The Manager,
Independent Planning Commission,
Level 15, 135 King St,
Sydney,
NSW 2000

Written Submission of Objection
Proposal : Bowdens Silver Mine proposal, SSD 5765

2.5 WASTE ROCK EMPLACEMENT

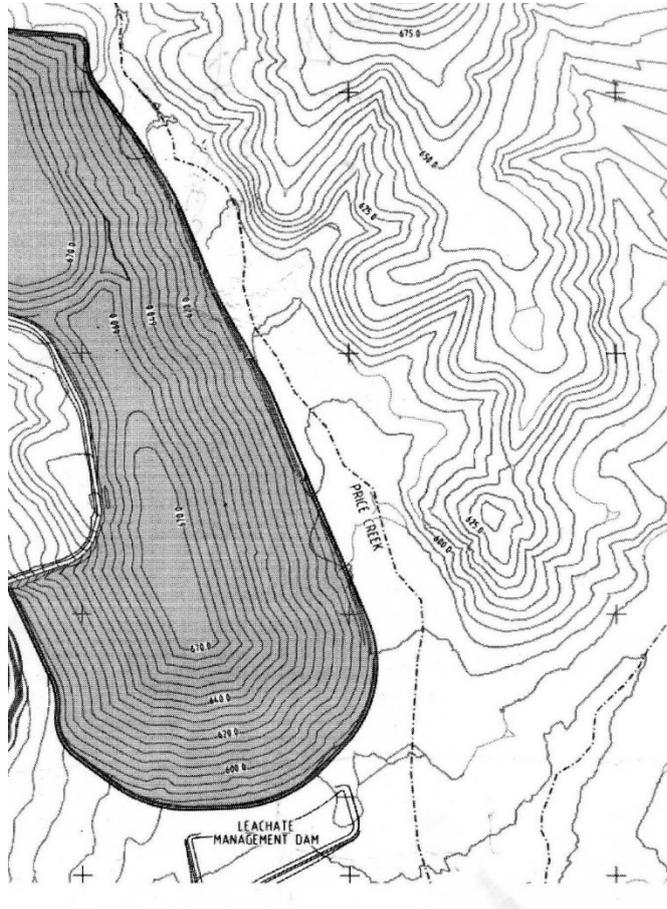
This is an ugly geometric engineered form. Bowdens claim that it has shaping to assimilate with the natural landscape. **It does not conform at all!** The following contour drawing by Bowdens show that clearly.

The grey blob is the WRE. On the right of the map are the natural contours of the native landscape. The variation in topography of the native landscape is significant. Sections would help the reader understand the proposal but they have not been provided by Bowdens.

Natural water relations in the locality (rainfall intensity and frequency) have derived a need for drainage creeks and swales every 200 metres. The proposed **WRE has none**. This must be a formula for **massive future erosion and the silting consequences etc**.

As it stands the WRE is 1600metres long (one mile), it has a ridge one kilometre long, the ridge is effectively horizontal (dominating a natural landscape noted for its varied ridge forms), it is 90 metres high (**taller than Sydney Opera House**). It will obscure the existing hills behind it.

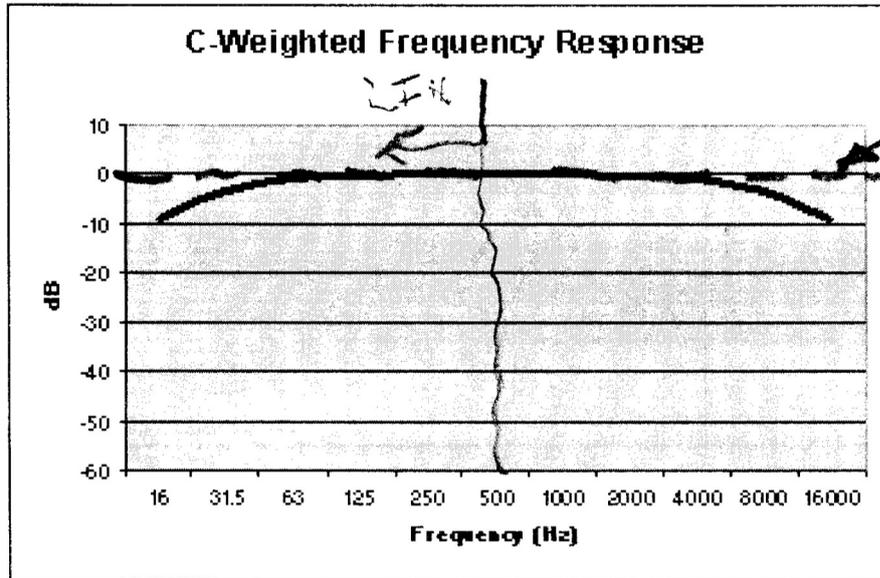
This A scale weighting is the most popular standard and it is used because it records and model the production and perception of the human voice. The curve shows omission of LFN.

As the reader can see in the sub 200 herz range there is very little response. Those noise monitors don't pick up the 10 to 160 herz low frequency noise. But for dBA and dBZ low frequency does exist:
